Our Case Number: ABP-314724-22

Re: Railway (Metrolink - Estuary to Charlemont via Dublin Airport) Order [2022]
Metrolink. Estuary through Swords, Dublin Airport, Ballymun, Glasnevin and City Centre to
Charlemont, Co. Dublin

**RE: SUBMISSION ON THE METROLINK RAILWAY ORDER APPLICATION IN
RELATION TO THE SITE OF A COMMERCIAL DEVELOPMENT AT 2 GRAND
PARADE, RANELAGH, DUBLIN 6.**

**RAILWAY (METROLINK-ESTUARY TO CHARLEMONT VIA DUBLIN AIRPORT)
ORDER 2022**

Fig 2.2B Proposed design intent at street level for the reconfigured stair and lift.

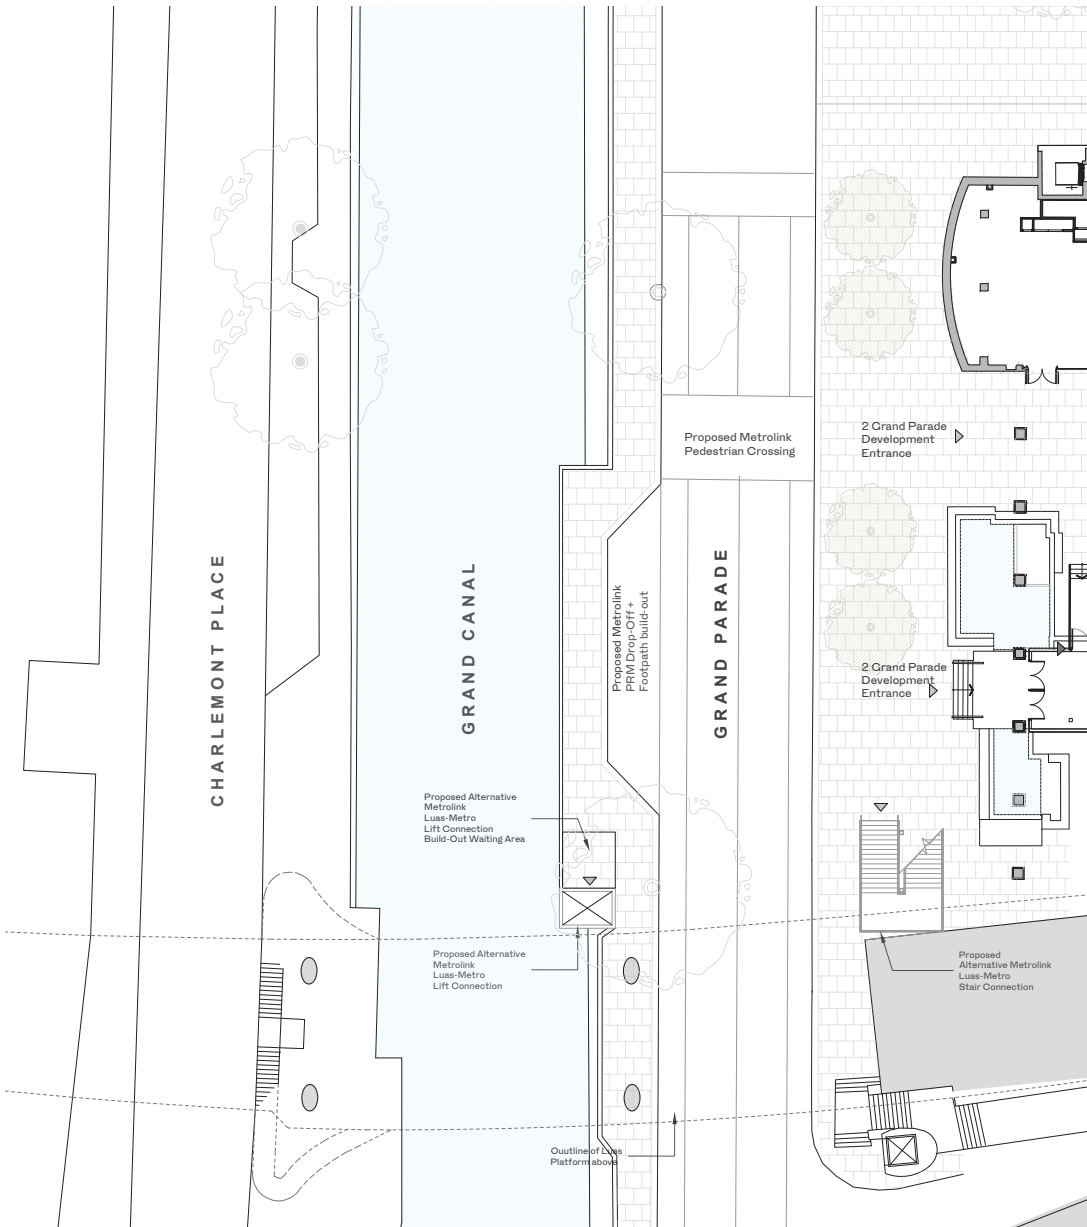
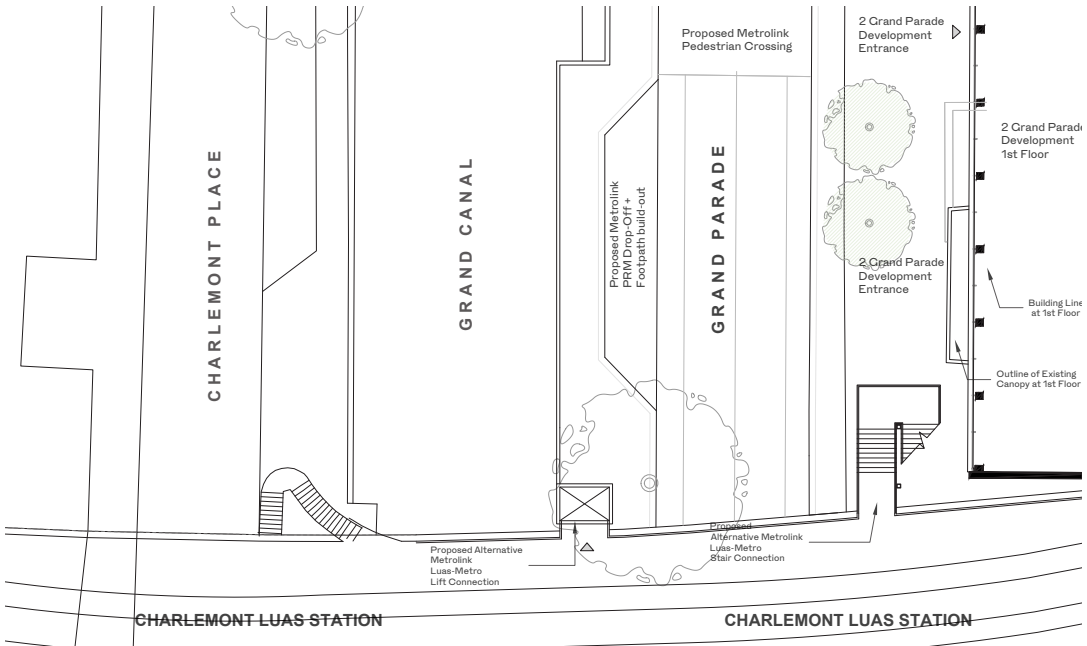
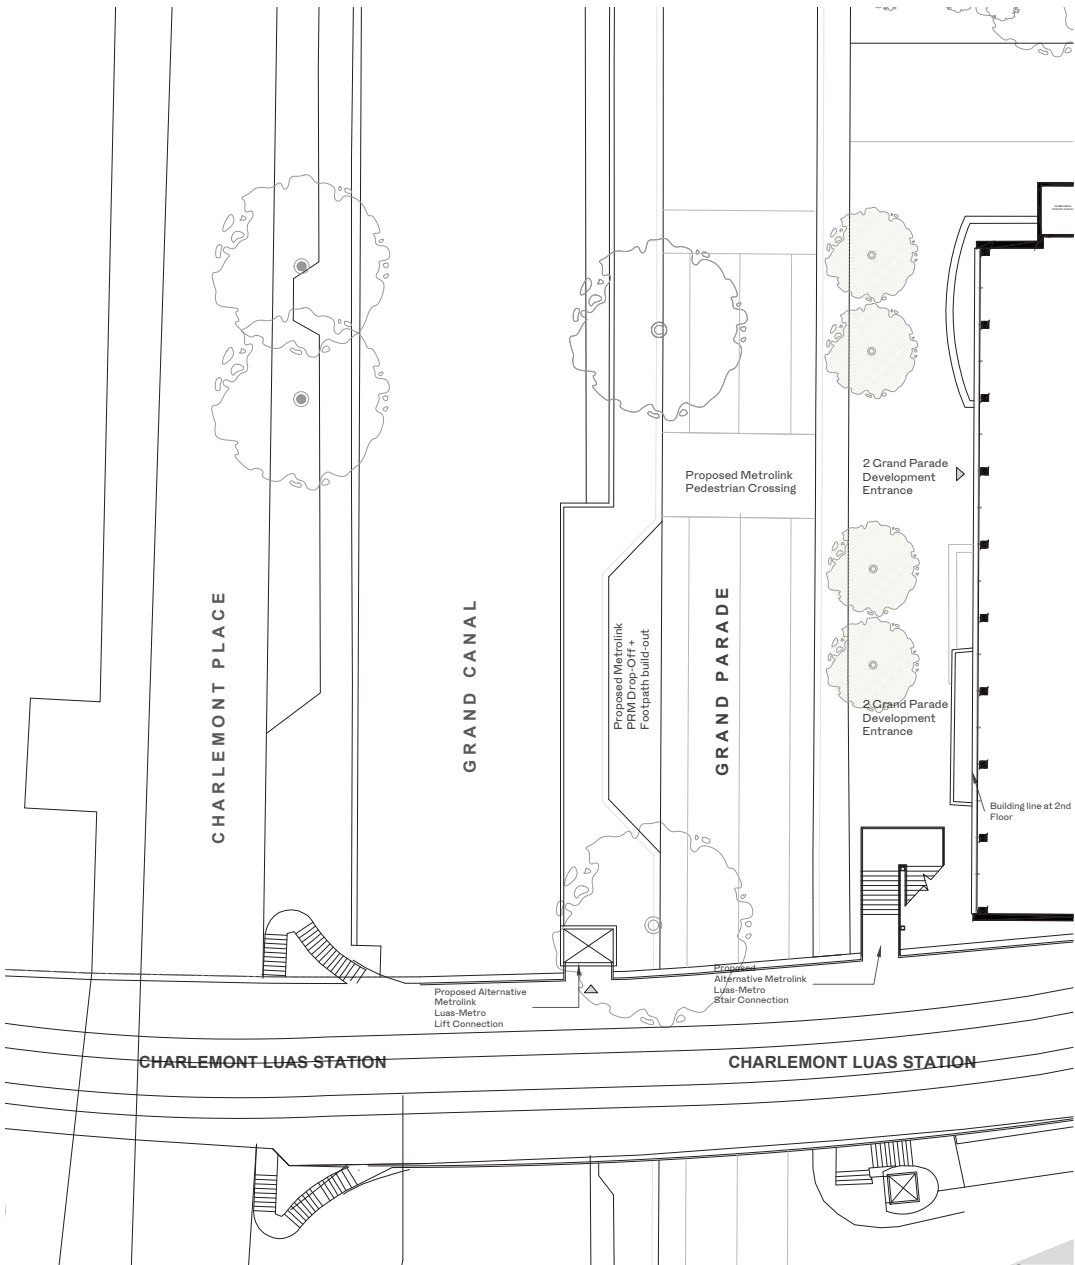
Refer to Figure 2.2B, C and D that demonstrate the potential alternative configuration of the stairs at street level and the lift re-located.

Refer to Figure 2.2E that shows the revised configuration at first floor level with the separation space between the stairs and the facade of protected structure increased as much as is potentially possible with the surrounding constraints.

It should be noted that a build-out of approximately 3.25m over the canal is proposed by the Railway Order application to accommodate the proposed PRM (Persons with Reduced Mobility) drop-off adjacent to this location. The short continuation of this proposed build-out would provide a direct connection from the drop off area to the lift.

It is requested that TII be conditioned to submit a revised design and layout for the interchange between MetroLink and the Charlemont Luas Stop, providing for the relocation of the proposed passenger lift to the north side of Grand Parade, thereby facilitating the repositioning of the proposed stair so as to provide a greater separation distance between the stair and the main entrance and facade of the protected structure.

Fig. 2 This image shows the impact of the proposals on the front setting with views of the front façade – in particular the important architecture at the lower level – being completely obstructed by a new staircase and lift.

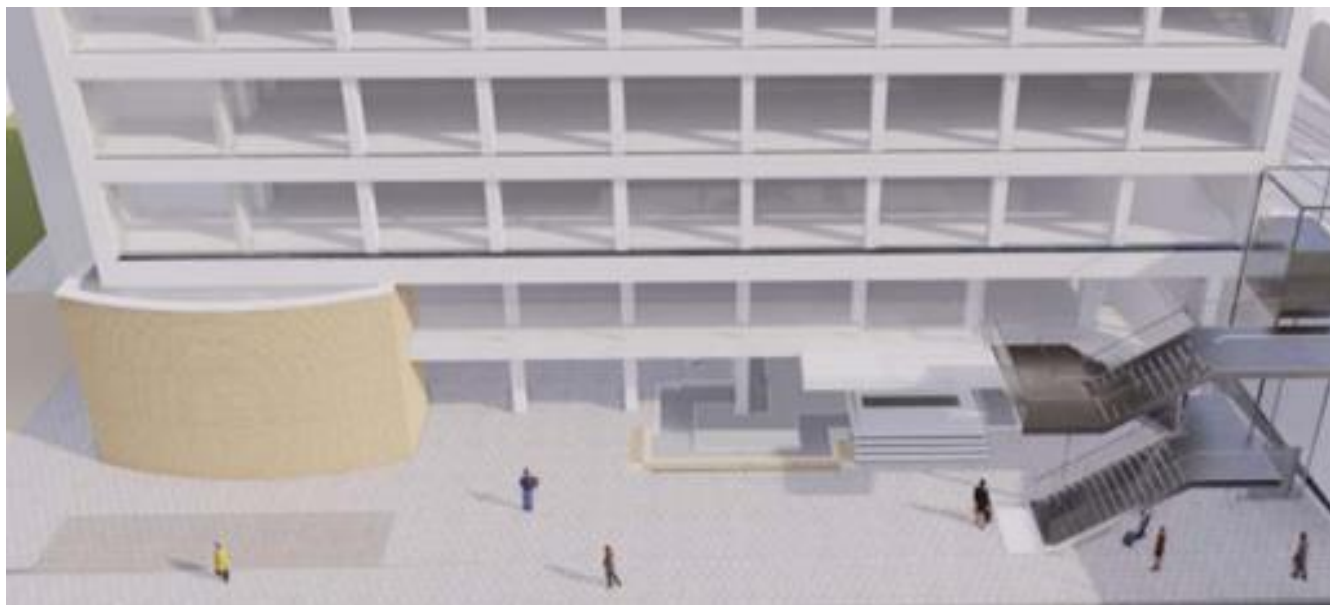
Clearly there will be a very significant impact on the most important aspect of this Protected Structure. The EIAR submitted by TII seems to concede this, when it notes that the impact arising from the proposals on the Protected Structure will be of a *'medium'* magnitude but that the impact will be *'very significant'*. The EIAR alludes to *'mitigation by design'* and suggests that the residual impact will be reduced to *'significant'* following mitigation. However, the EIAR offers no clue as to what this mitigation might be.
